RE: ENERGY STAR® Clothes Dryers Draft 2 Version 1.0 Specification

This letter comprises the comments of the Pacific Gas and Electric Company (PG&E), Southern California Gas Company (SCGC), San Diego Gas and Electric (SDG&E), and Southern California Edison (SCE) in response to the Environmental Protection Agency (EPA) ENERGY STAR® Clothes Dryers Draft 2 Version 1.0 Specification.

**Figure 1: Power over time plot of conventional dryer across different drying modes.**

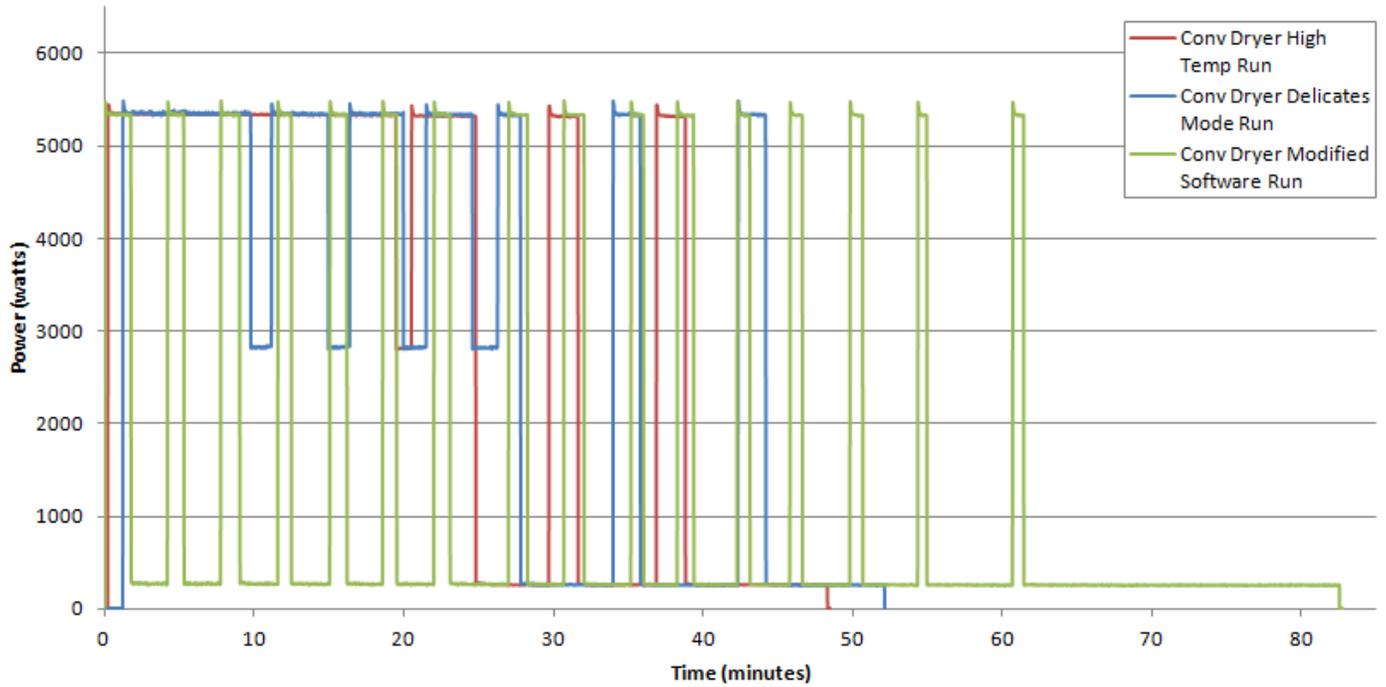
Figure 1 shows a typical power over time profile of low-temperature versus high-temperature behavior.

**Figure 2: Cumulative energy consumption over time for full size conventional dryer across different drying modes.**

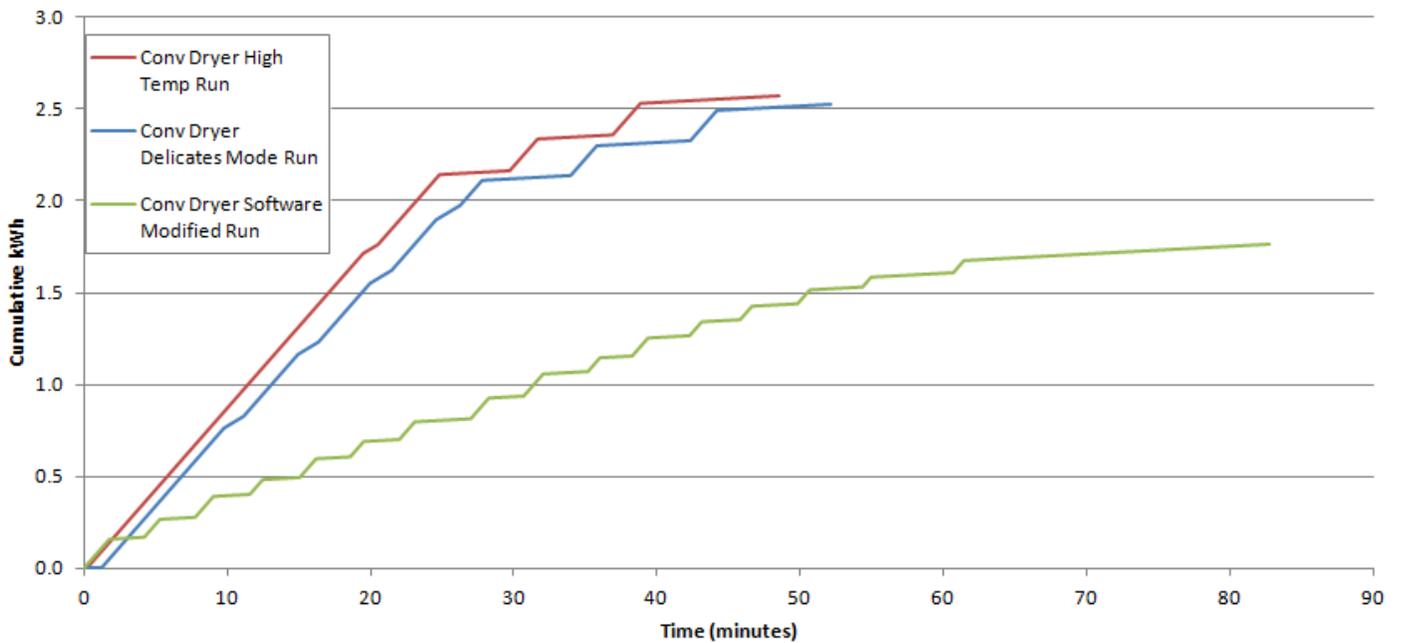
Figure 2 shows the same data plotted cumulatively. On average across five conventional electric dryer models, this lengthened drying time by 23% and increased efficiency by 3% (see Figure 4).

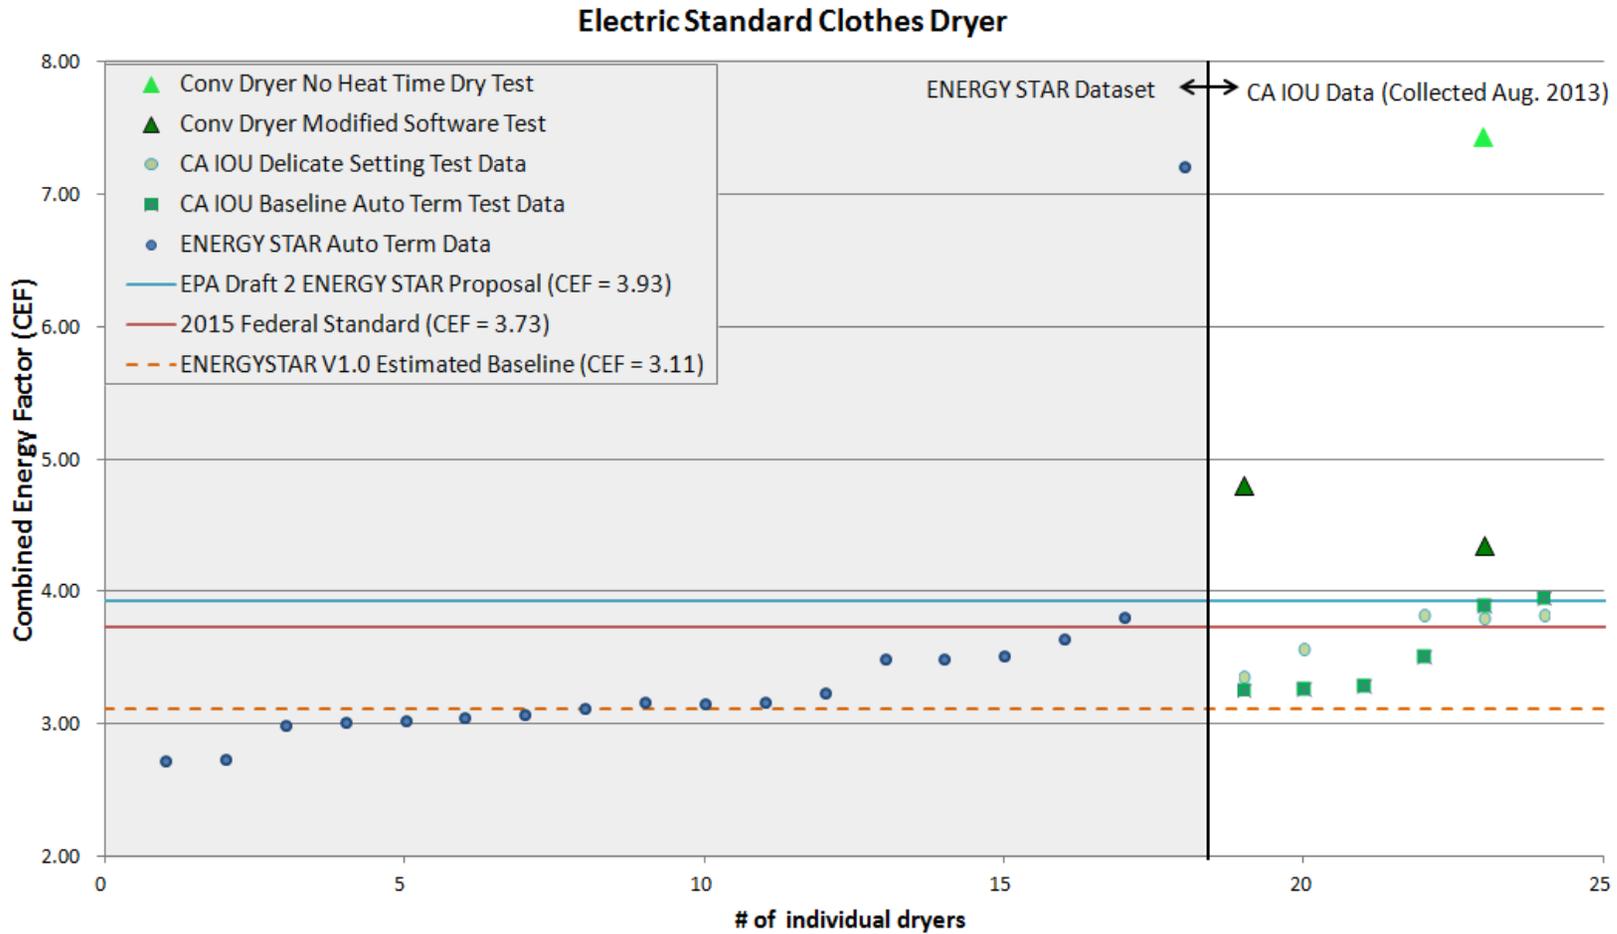
Because the results of the tests performed in low-temperature mode (also referred to as “Delicates Mode”) resulted in modest changes to efficiency, we took one high-end dryer and one entry-level dryer and modified how they behaved. We switched the mode to no heat periodically to maintain a low exhaust temperature. The “Conv Dryer Modified Software Run” in Figure 1 shows a typical power over time profile of this behavior. Across two conventional electric dryer models, this lengthened drying time by 141% and increased efficiency by 30% (see Figure 4).

This interspersing of no-heat mode lengthened the drying times significantly, but allowed both dryers to pass the EPA-proposed 3.93 CEF easily (Figure 6). Manufacturers could make this behavior the default mode that the DOE test procedure specifies. Many, if not most, consumers will find such factor of 2-3 drying time extensions to be unacceptably long and will instead choose a faster mode. Since the Draft 2 specification does not require testing in faster modes, there is no reason to believe, however, that the faster mode will deliver any energy savings compared to a conventional, non-ENERGY STAR dryer. As a result, if the Draft 2 specification is finalized as proposed, consumers could purchase dryers that provide them with only a fraction of the energy savings, if any, that the ENERGY STAR label promises.

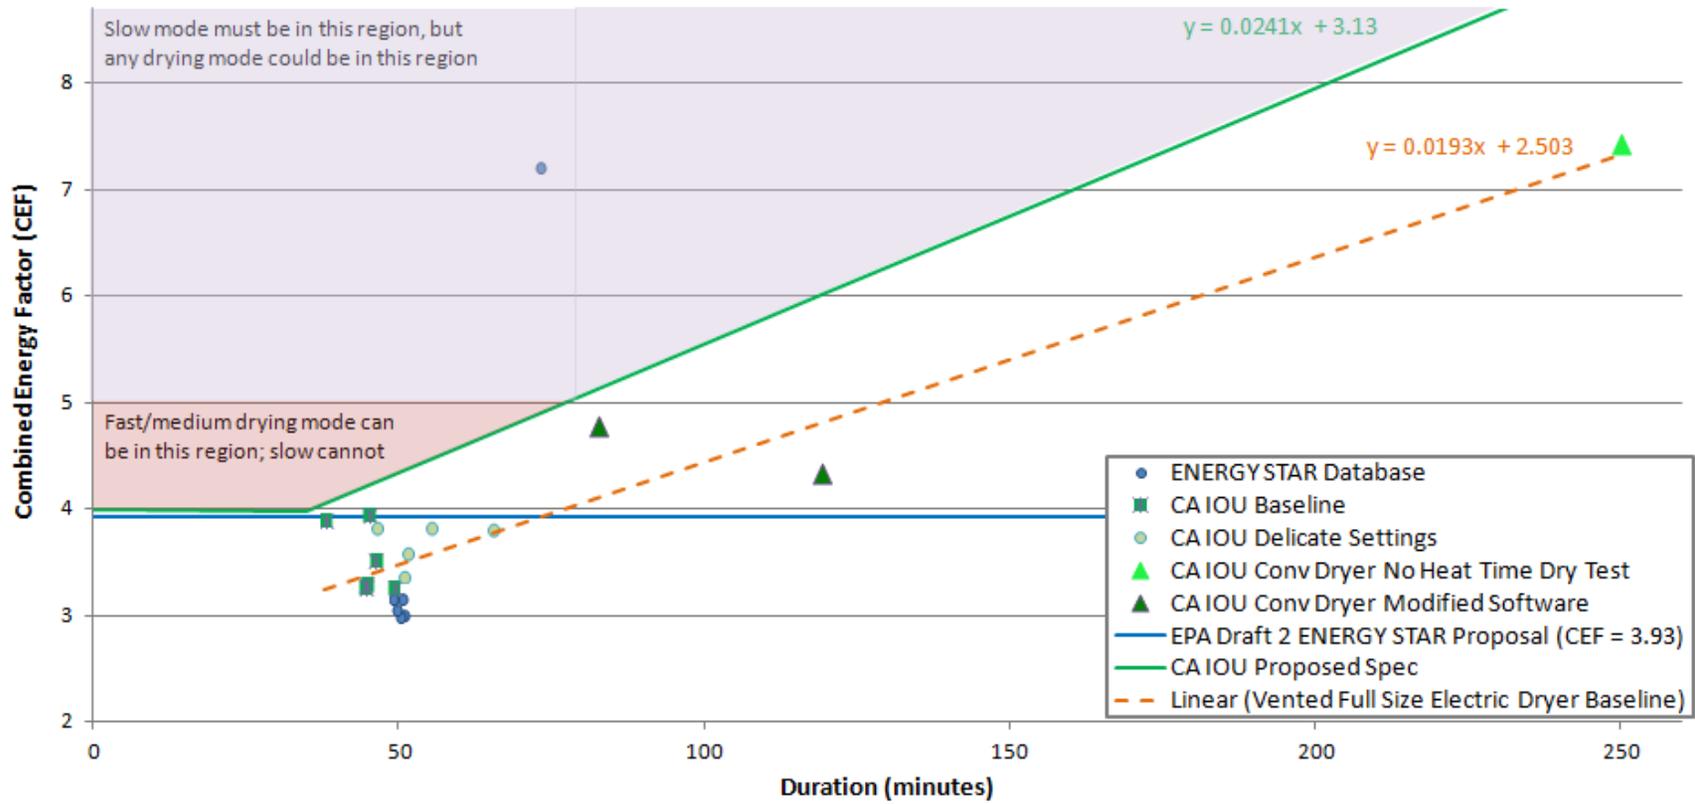
As Figure 4 demonstrates, we have constructed a potential specification that we propose EPA use to link efficiency criteria to drying time. In order to construct our proposal, we first found the best-fit CEF line with conventional dryers (see Figure 6). We ran one high-end dryer in no-heat mode to test the extreme case.<sup>6</sup> With no heat, the dryer is relying on the natural desiccating capability of the room air. With the energy used to spin the fan and drum, drying occurs at about twice the efficiency of a conventional dryer in heat mode, but it takes about five times as long. This also explains the above results: slowing the drying down by running a significant fraction of the time in no-heat mode increases the efficiency.

Slow mode: the user manual should indicate the slow test settings. This could be an eco-mode or the lowest available temperature that performs automatic termination. The CEF must be greater than or equal to 5.0 and on or above the specification line (see Figure 4).

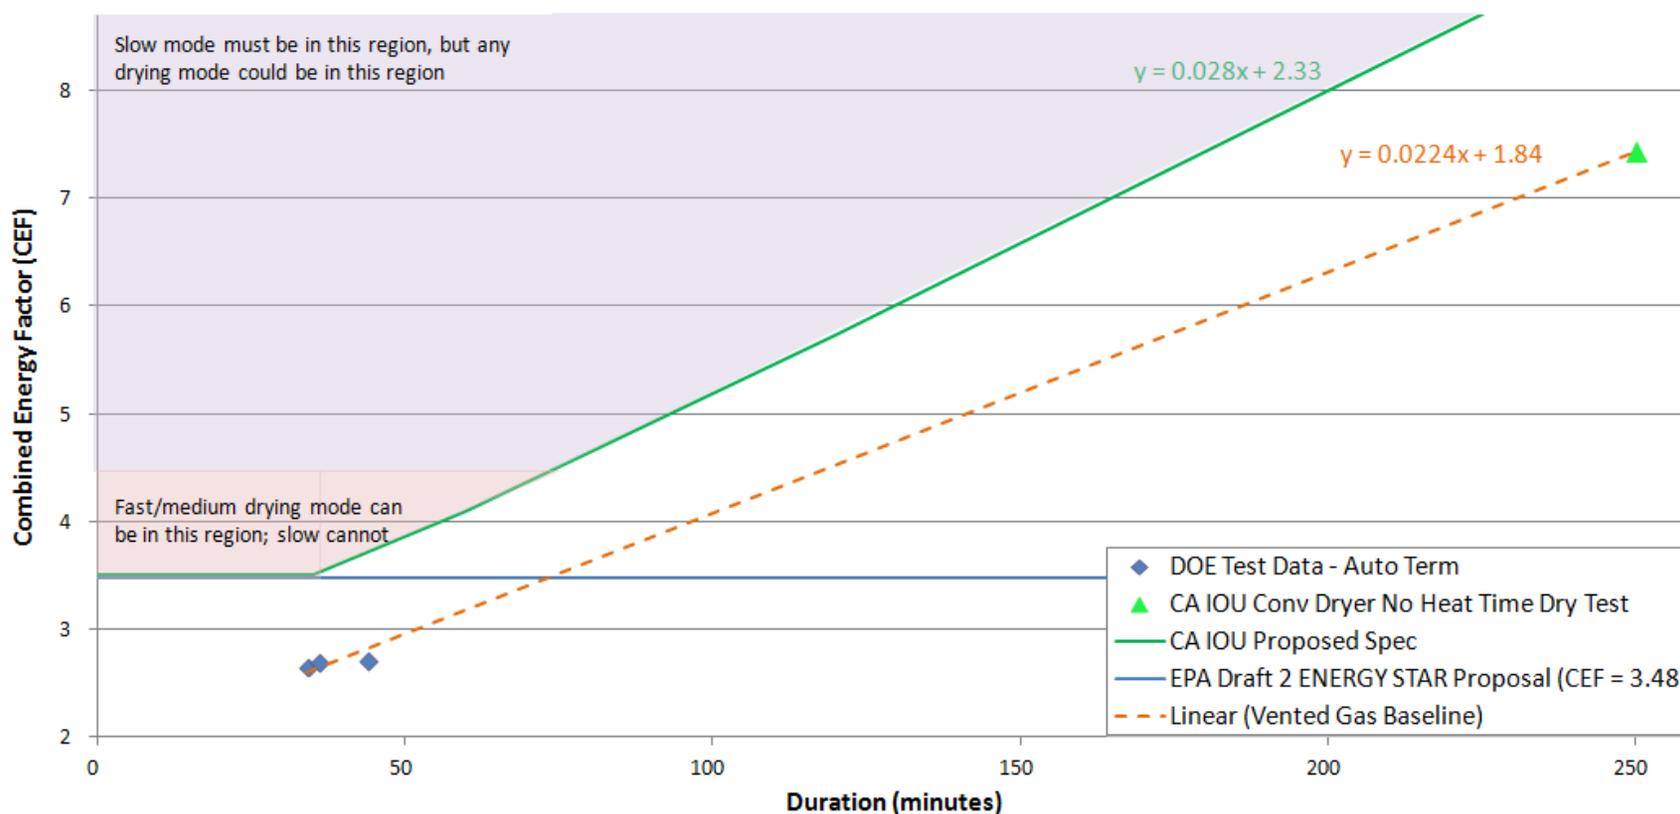
For gas dryers, EPA should also adopt a specification line that increases with drying time in order to guarantee that the dryers have improvements other than simply slowing the drying down. The extreme case for gas dryers of no heat would be nearly identical to electric dryers, so we have used the electric data point (see Figure 7). Also, interspersing heat mode with no-heat mode would again increase the CEF significantly. Therefore, we used the same procedure of curve fitting the baseline and then multiplied by 1.266 (corresponding to 21% energy savings as in the EPA proposal) for the IOU proposal (see Figure 7). Also, the horizontal section of the proposed specification line roughly corresponds to the EPA proposal of  $CEF = 3.48$ .

Testing in the same three modes would be required to ensure that consumers have a very high efficiency choice and that energy is saved in all drying speeds. We propose that the slow mode minimum CEF correspond to similar drying time as in electric dryers. This would correspond to  $CEF = 4.4$  (see Figure 5).

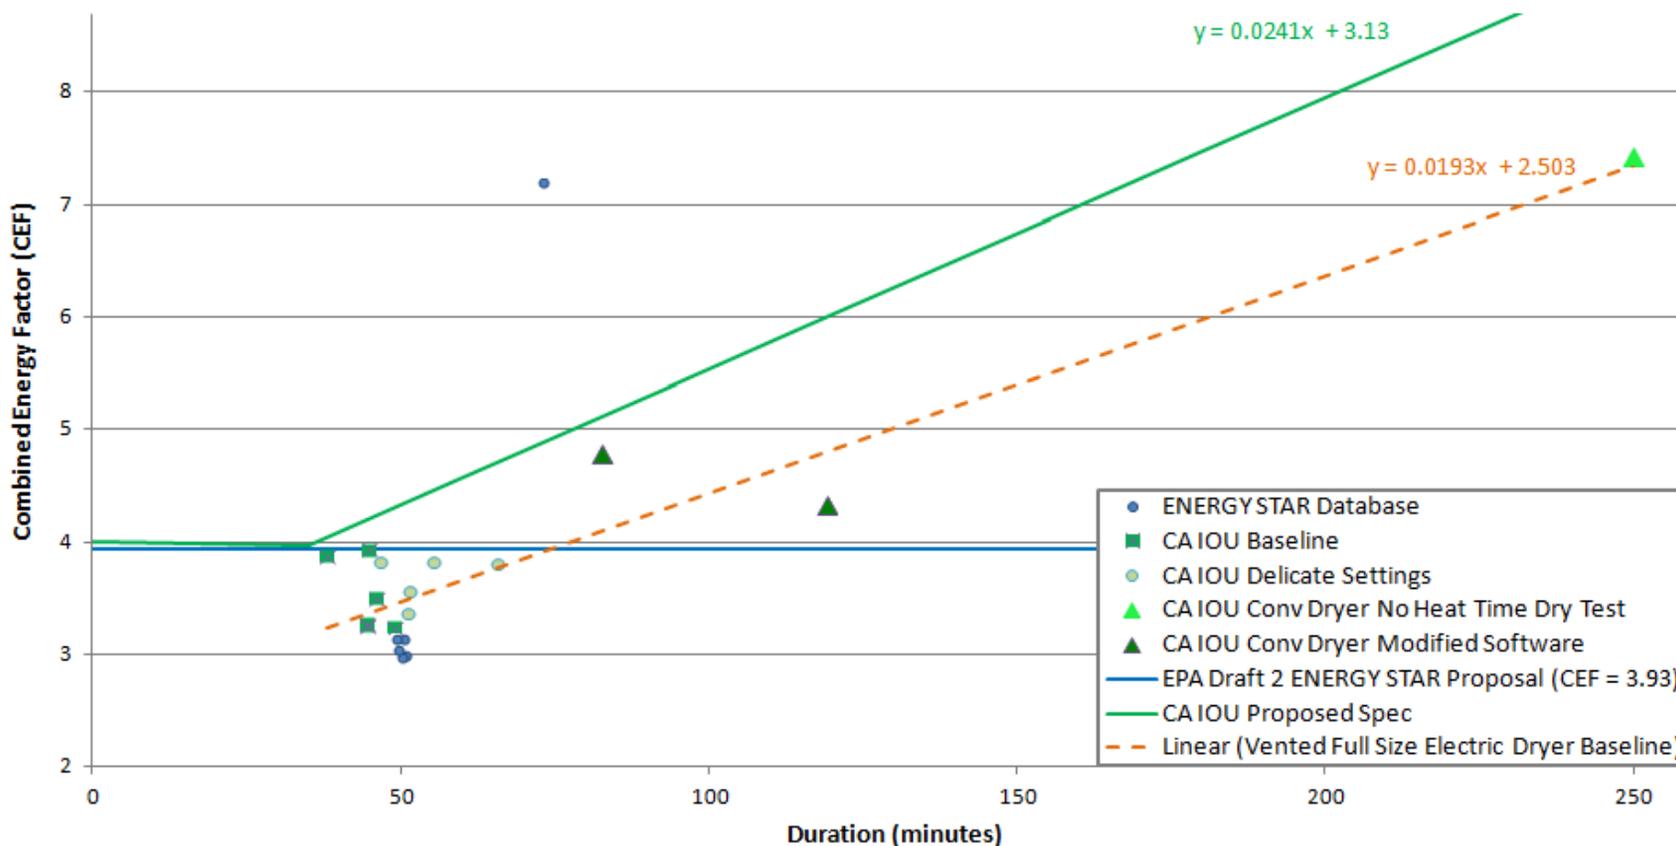
For our proposal, we took this baseline curve fit and multiplied both the intercept and coefficient to the drying time by 1.25, representing the 20% energy savings<sup>7</sup> currently proposed by EPA (see Figure 6). Note that the heat pump dryer CEF is significantly above the proposed specification line, making it likely that heat pumps are not the only technology capable of earning the ENERGY STAR label under the IOU proposal. EPA has identified many different possible efficiency improvements in dryers that would help enable manufacturers to meet this specification; these measures include improved automatic termination, improved motor, more efficient blower blades, and lower pressure drop ducting inside the dryer.<sup>8</sup> We propose not to give additional energy use allowance for even faster drying time than typical dryers (the horizontal section of the green line in Figure 6).

This same proposed specification line would ensure that there would be some intrinsic improvement in the dryer in the mode measured and that dryers could not earn the ENERGY STAR label just by slowing the drying down (see Figure 6). The drawback to this approach, however, is that it would not guarantee energy savings in all drying speeds available. Similarly, it would not guarantee that consumers have the choice of setting a very high efficiency, slow drying mode.

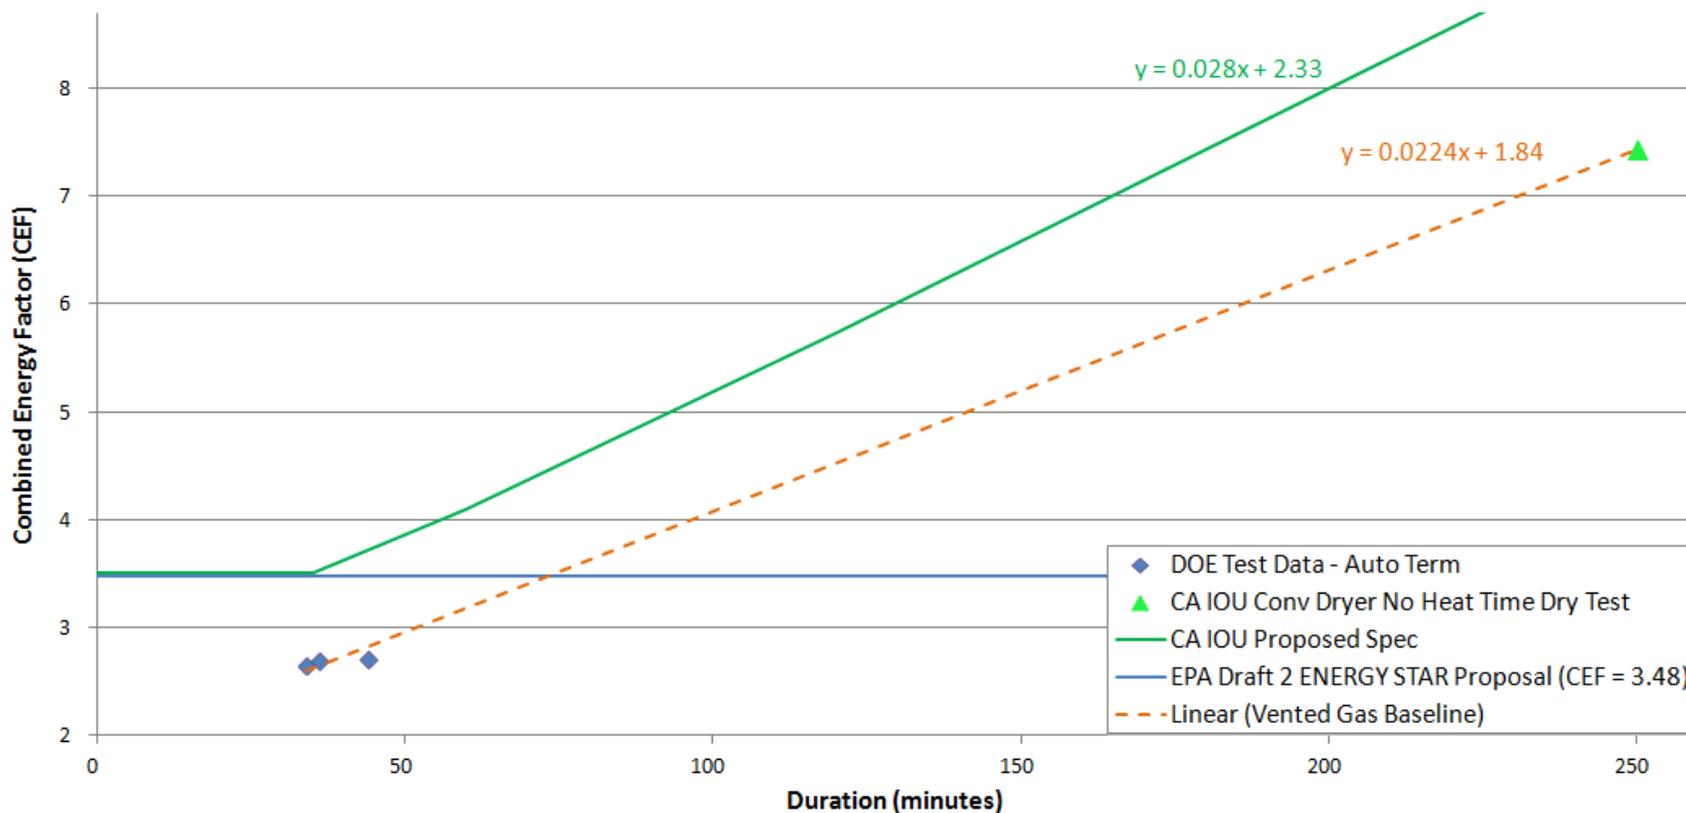
This same proposed specification line would ensure that there would be some intrinsic improvement in the dryer in the mode measured and that dryers could not earn the ENERGY STAR label just by slowing the drying down (see Figure 7). Again, the drawback to this approach is that it would not guarantee energy savings in all drying speeds available. Similarly, it would not guarantee that consumers have the choice of setting a very high efficiency, slow drying mode.
